## Product Change Notice

**Title of Change:** TA-2MD – Product Specification Change

Part Number	Product Description
TA-2MD	Resistive Termination DC-6GHz, 2W 7-16(m) Indoor

### Mechanical Outline

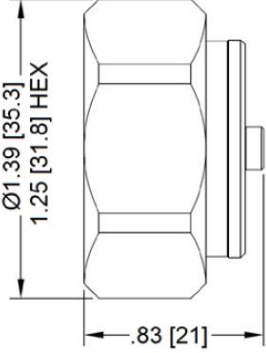
**Type of Change:** Electrical Operation & Mechanical Dimensions

**Change Description** The TA-2MD resistive termination has been enhanced with improved VSWR performance across its full operating frequency range of DC–6.0 GHz. The temperature rating has also been expanded to –40 °C to +65 °C. In addition, the mechanical design has been updated with the addition of a finned heat sink to further improve thermal management.
